UNITED STATES PATENT AND TRADEMARK OFFICE

APPLICATION NO.	FILING DATE	FIRST NAMED INVENTOR	ATTORNEY DOCKET NO.	CONFIRMATION NO.
10/797,571	03/11/2004	Akihiro Moto	033035M143	4805

Office Action Summary	Application No. 10/797,571	Applicant(s) MOTO, AKIHIRO	
	Examiner DELMA R. FLORES RUIZ	Art Unit 2828

DETAILED ACTION

Figures 11 and 12

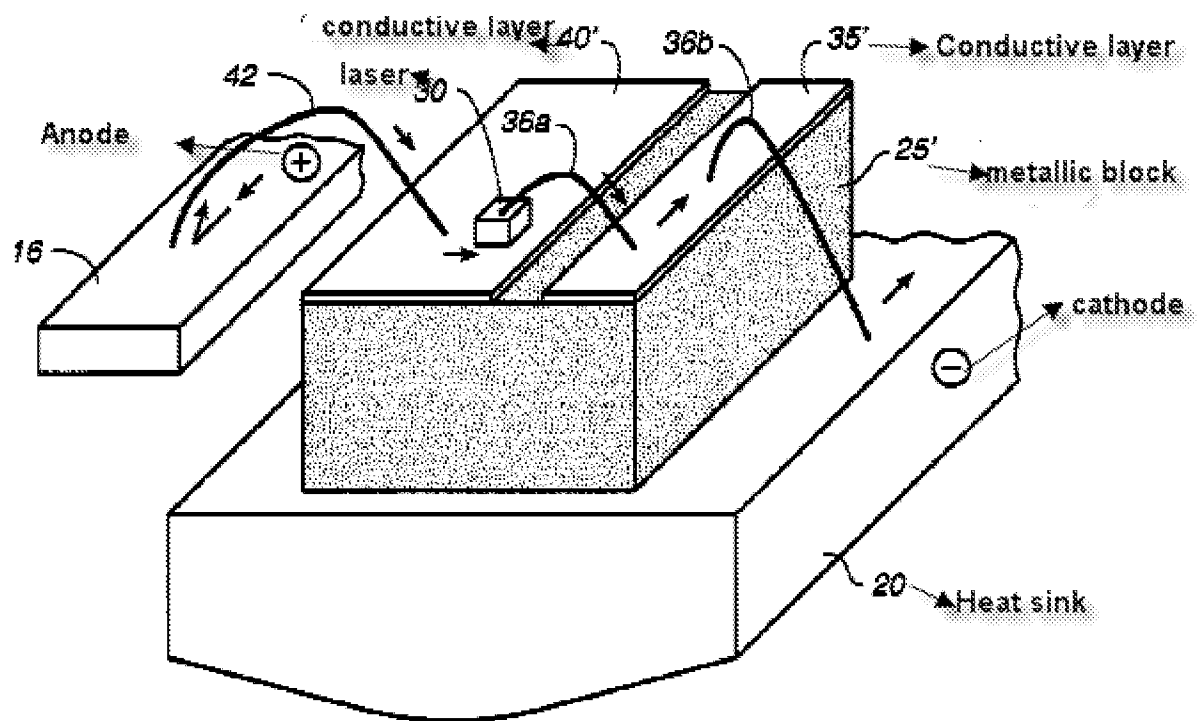
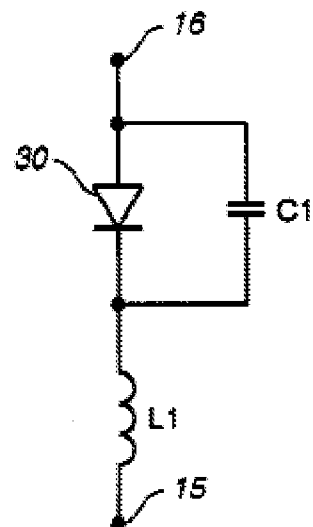
Regarding claim 2, Uchida discloses in Figure 11 and 12 a light-transmitting module, comprising: a stack of a metallic block (see Fig. 11, Character 25', Column 2, Lines 20 – 21), an insulating heat sink (see Fig. 11, Character 20) mounted on said metallic block and an electrically conductive layer (see Fig. 11, Characters 35' and 40') formed on said insulating heat sink, said stack forming a parallel-plate capacitor; and a laser diode (see Fig. 11, Character 30) having an anode and a cathode, said laser diode being mounted on said conductive layer such that said anode faces and is in contact with said

conductive layer (Column 1, Lines 31 – 34, Column 2, Lines 11 – 41 and Column 3, Lines 1 – 10).

Uchida disclose the claimed invention except for capacitor is at least 50pF. However, it is well known in the art to apply the capacitor is at least 50pF. Therefore, it would have been obvious to a person having ordinary skill in the art at the time the invention was to apply the well known the capacitor is at least 50pF, because could be used to accumulating and holding a small charge of electricity, since it has been held that discovering an optimum value of a result effective variable involves only routine skill in the art. In re Boesch, 617 F.2d 272, 205 USPQ 215 (CCPA 1980).

Uchida discloses the claimed invention except for heat sink includes a groove for securing an optical fiber. Crane teaches a heat sink includes a groove for securing an optical fiber. However, it is well known in the art to apply heat sink includes a groove for securing an optical fiber as discloses by Crane in (See Figure. 3, Character 70 and Figure, 8, and Paragraphs [0002 and 0058]). Therefore, it would have been obvious to a person having ordinary skill in the art at the time the invention was to apply the well known heat sink includes a groove for securing an optical fiber as suggested by Crane to the laser of Uchida, because could be used for communication of analog or digital signals see (Paragraphs [0002]) of Crane.

Regarding claim 15, Uchida discloses in Figure 11 and 12 a light-transmitting module, comprising: a stack of an electrically conductive heat sink (see Fig. 11, Character 25', Column 2, Lines 20 – 21), an insulating layer provided on said heat sink (21see Fig. 11, Character 20) and an electrically conductive layer (see Fig. 11, Characters 35' and 40'), said stack forming a parallel-plate capacitor; and a laser diode (see Fig. 11, Character 30) mounted having an anode and a cathode, said laser diode being mounted on said conductive layer such that said anode faces and is in contact with said conductive layer (Column 1, Lines 31 – 34, Column 2, Lines 11 – 41 and Column 3, Lines 1 – 10).

Uchida disclose the claimed invention except for capacitor is at least 50pF. However, it is well known in the art to apply the capacitor is at least 50pF. Therefore, it would have been obvious to a person having ordinary skill in the art at the time the invention was to apply the well known the capacitor is at least 50pF, because could be used to accumulating and holding a small charge of electricity, since it has been held that discovering an optimum value of a result effective variable involves only routine skill in the art. In re Boesch, 617 F.2d 272, 205 USPQ 215 (CCPA 1980).

Uchida discloses the claimed invention except for heat sink includes a groove for securing an optical fiber. Crane teaches a heat sink includes a groove for securing an optical fiber. However, it is well known in the art to apply heat sink includes a groove for securing an optical fiber as discloses by Crane in (See

Figure 3, Character 70 and Figure 8, and Paragraphs [0002 and 0058]). Therefore, it would have been obvious to a person having ordinary skill in the art at the time the invention was to apply the well known heat sink includes a groove for securing an optical fiber as suggested by Crane to the laser of Uchida, because could be used for communication of analog or digital signals see (Paragraphs [0002]) of Crane.
